C2194E BUILDING D FUME HOOD MECHANICAL AND PLUMBING UPGRADE PROJECT
AT THE
LIBERAL ARTS CAMPUS

ADDENDUM NO. 1

April 9, 2021

THIRD FLOOR PLAN

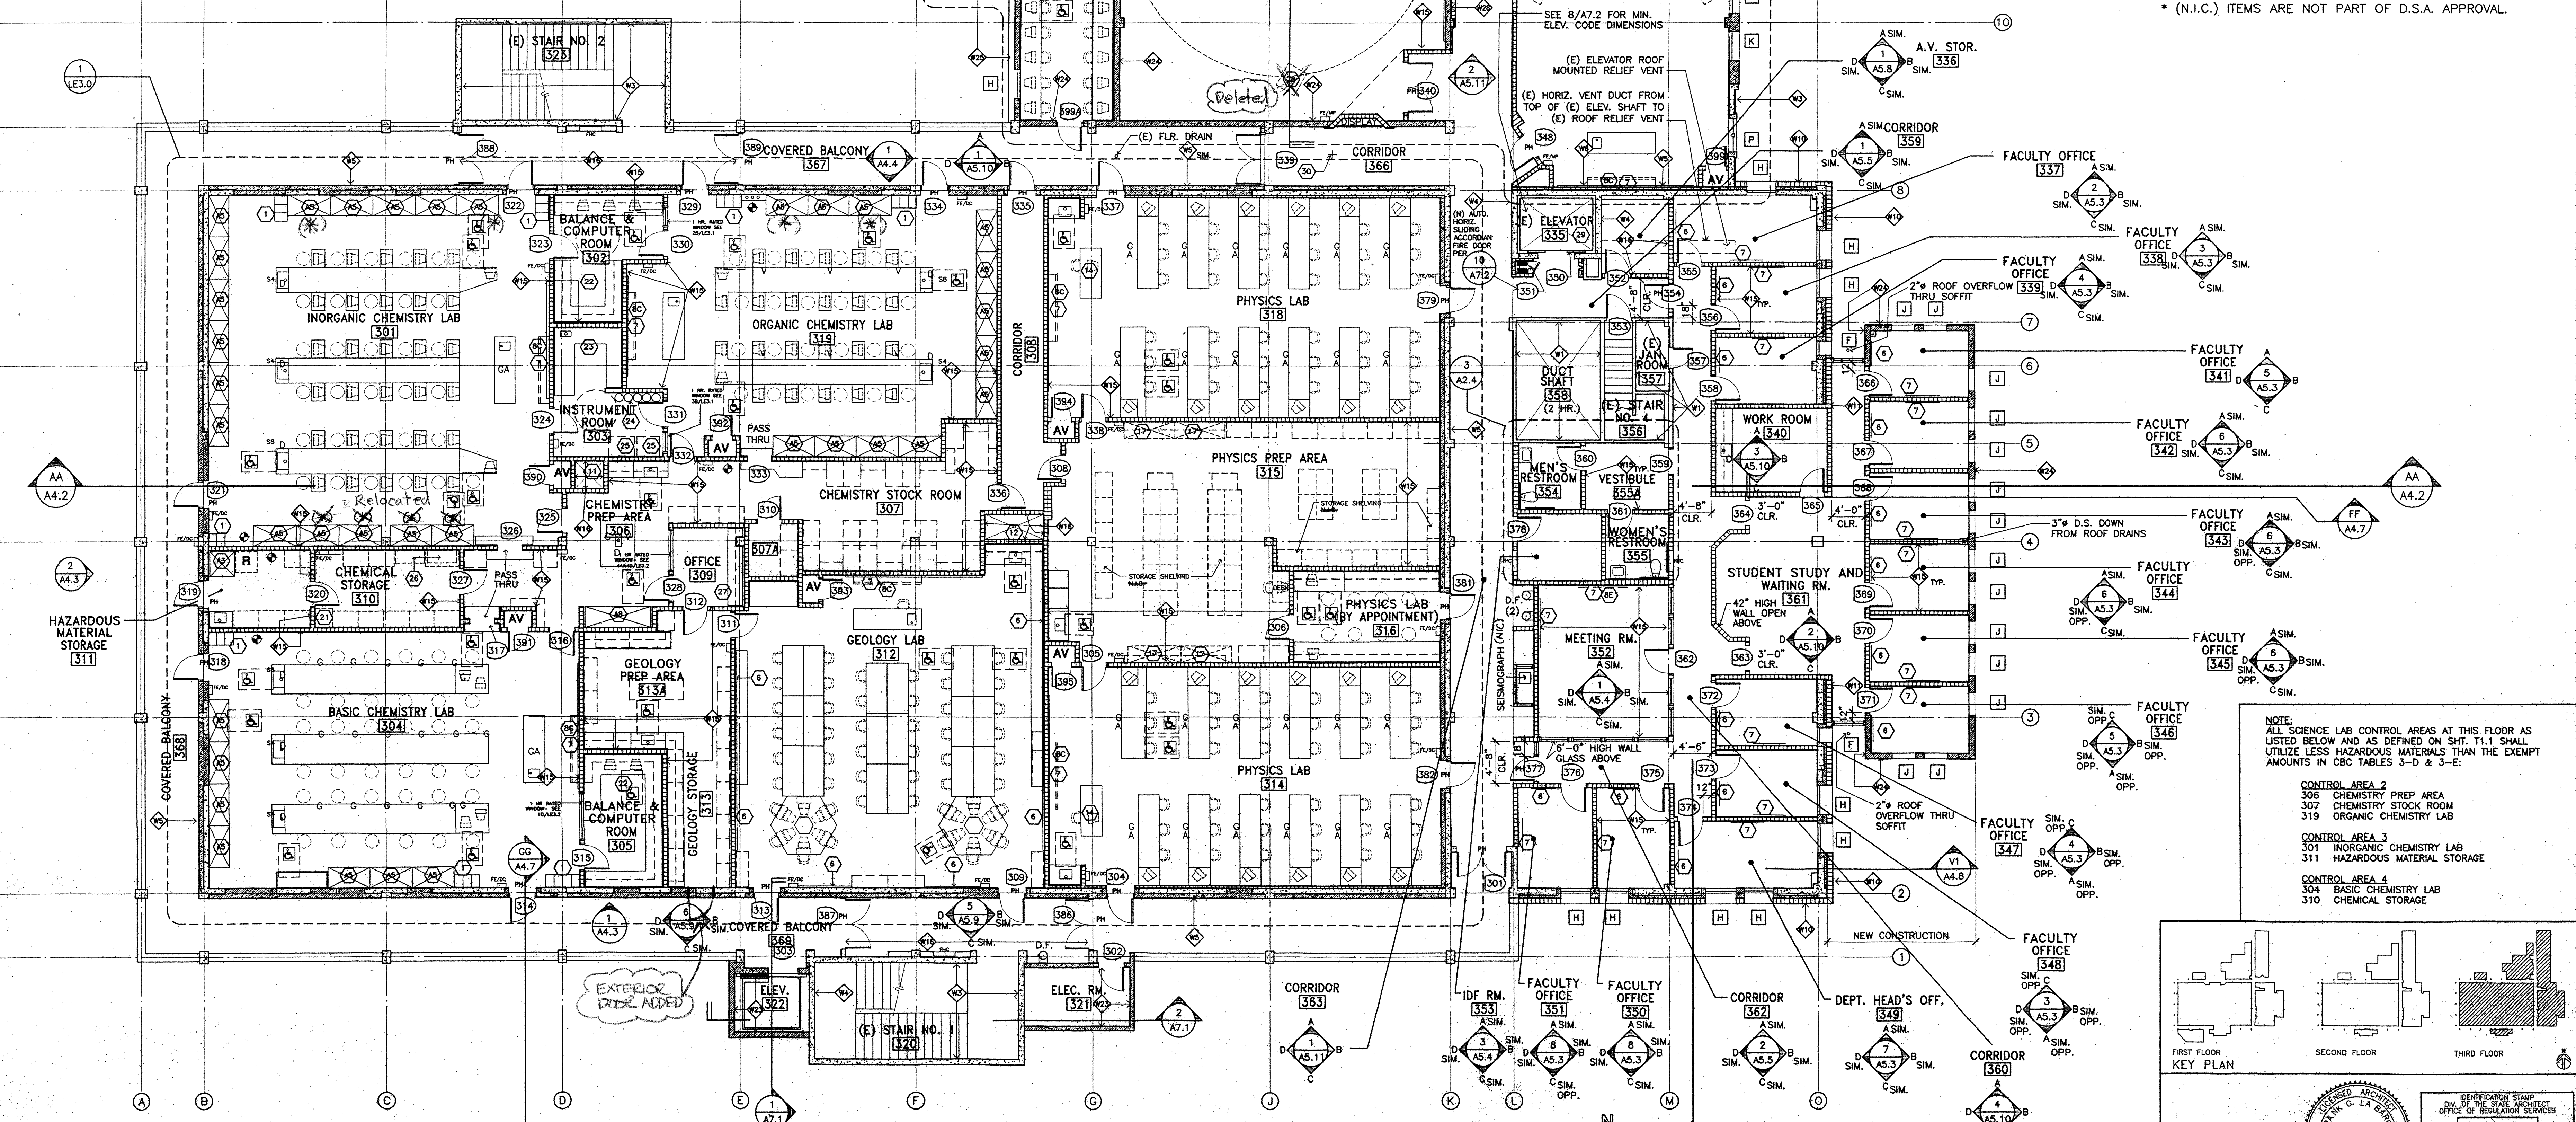
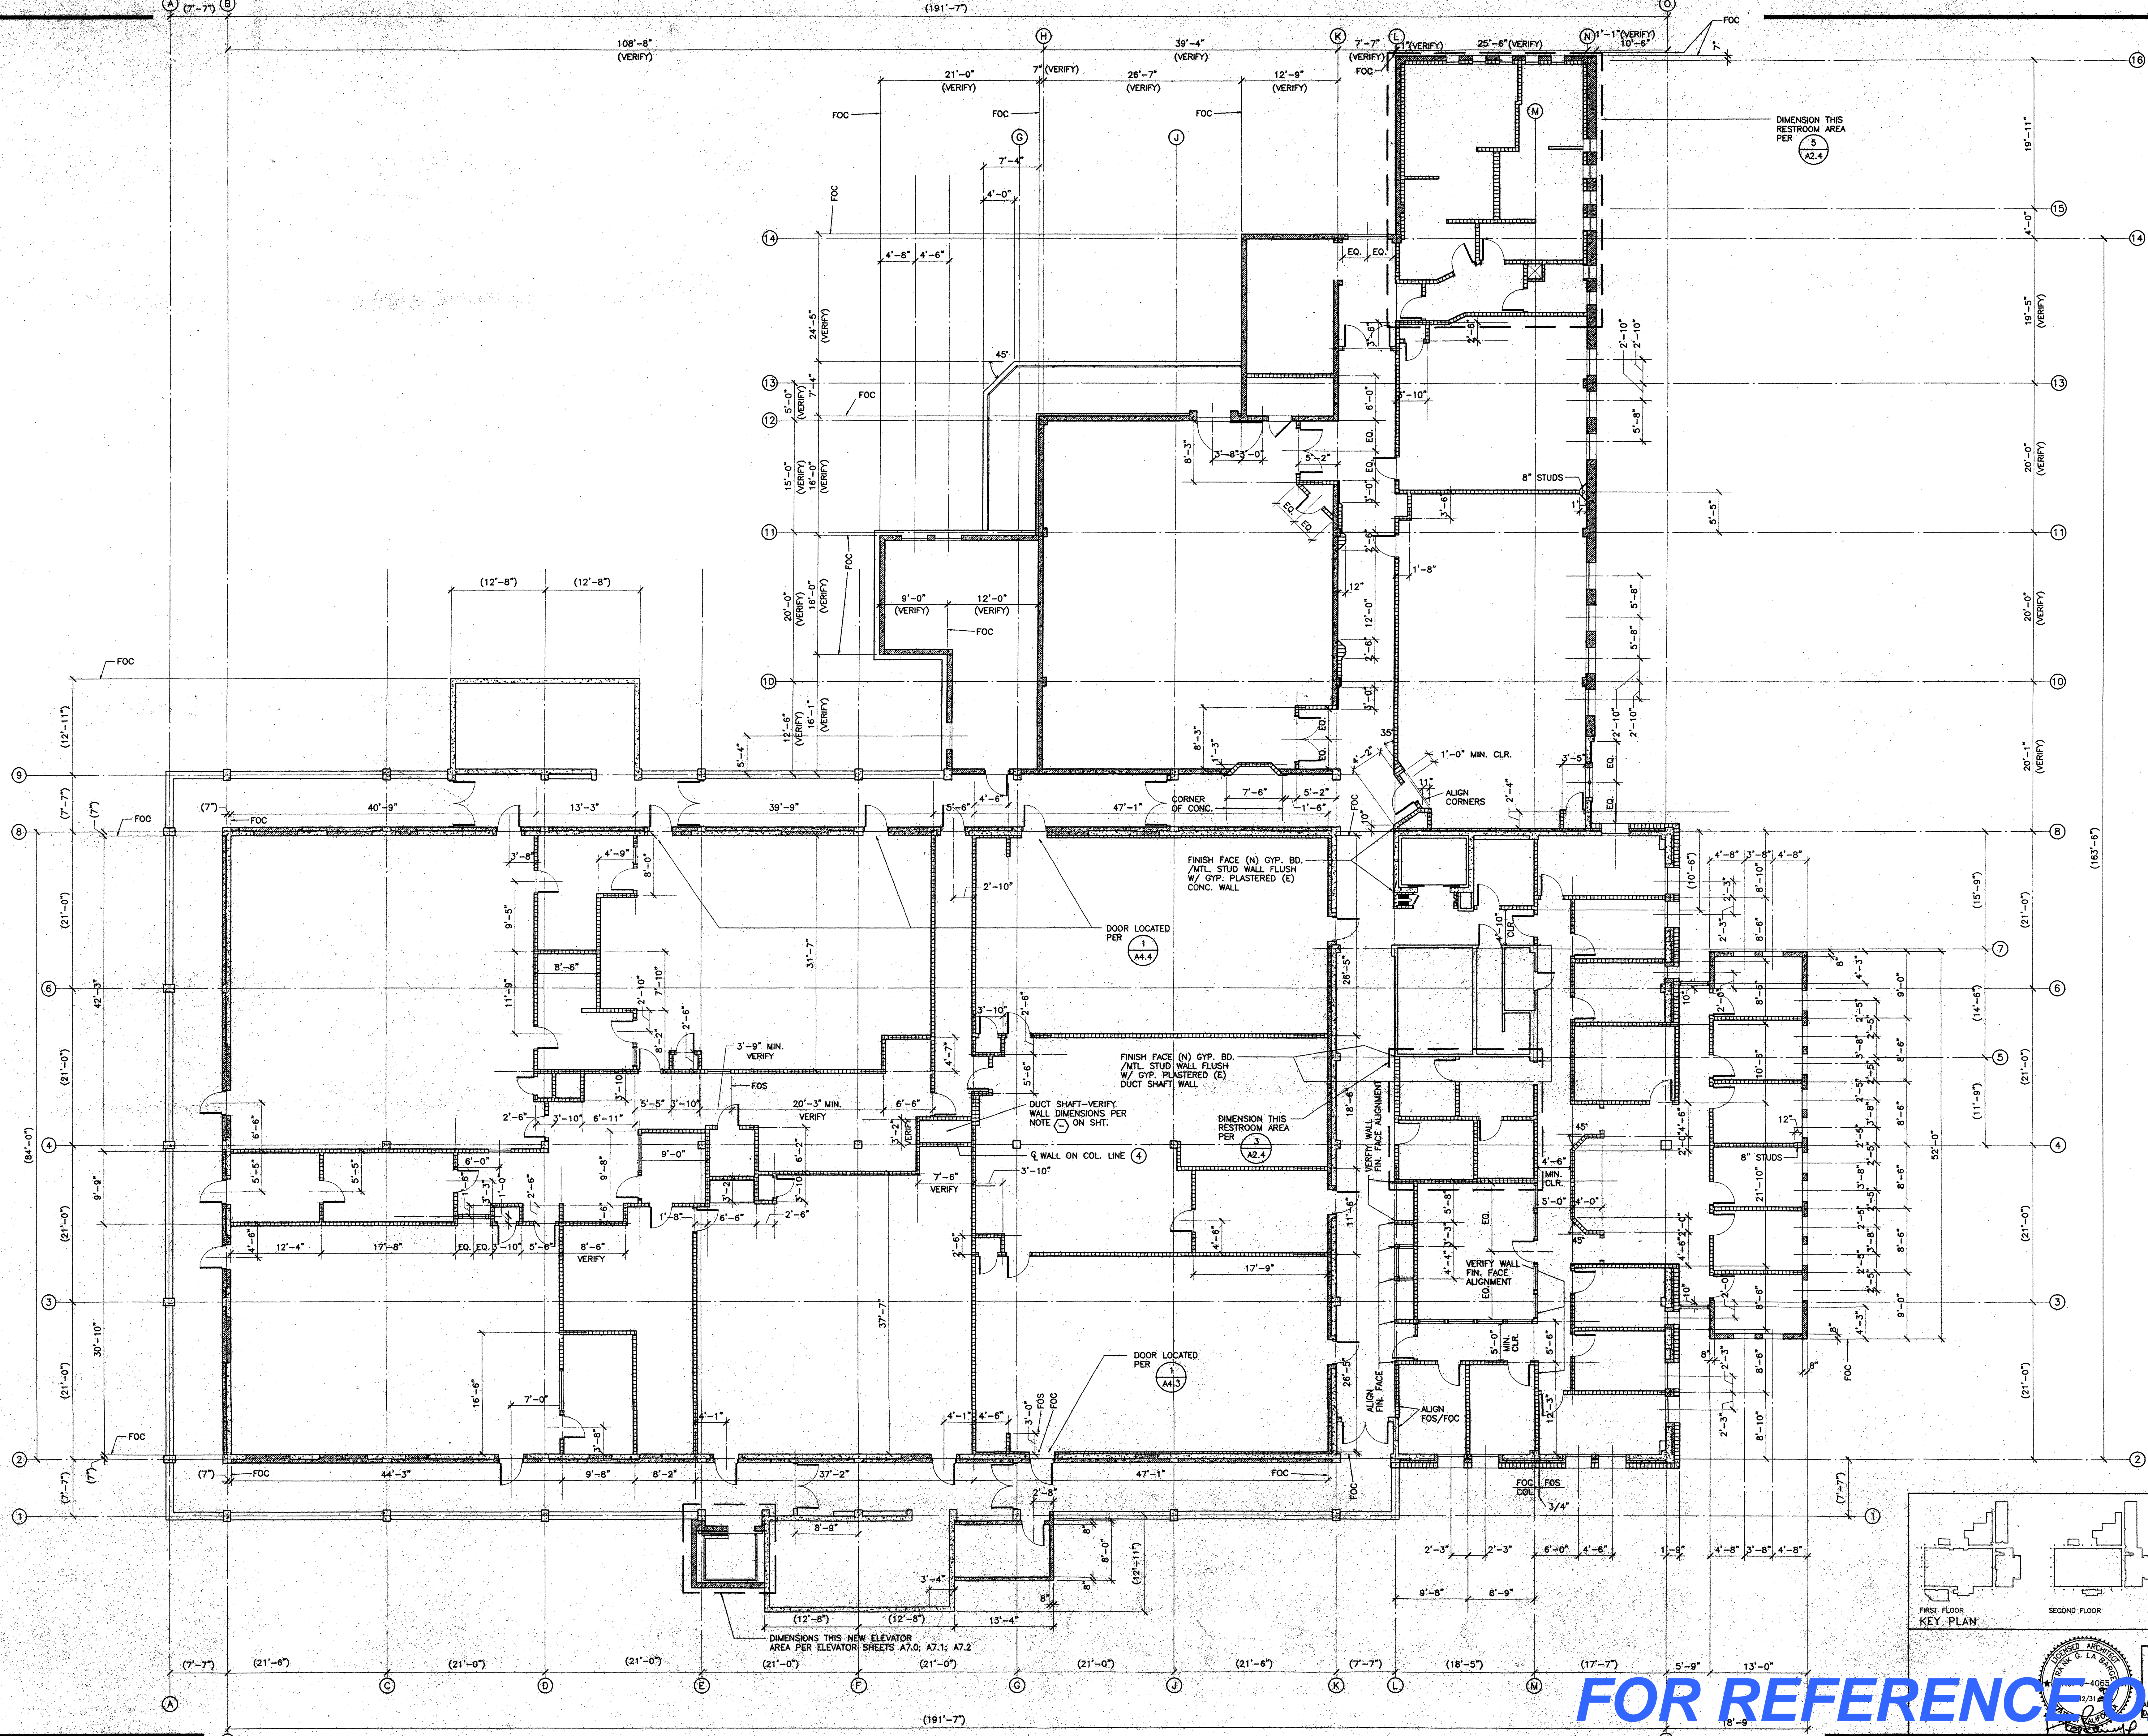
4. *Q: What is the height above the acoustical ceiling on the third floor?*

A: See Attachment 1: Building D As-Builts.
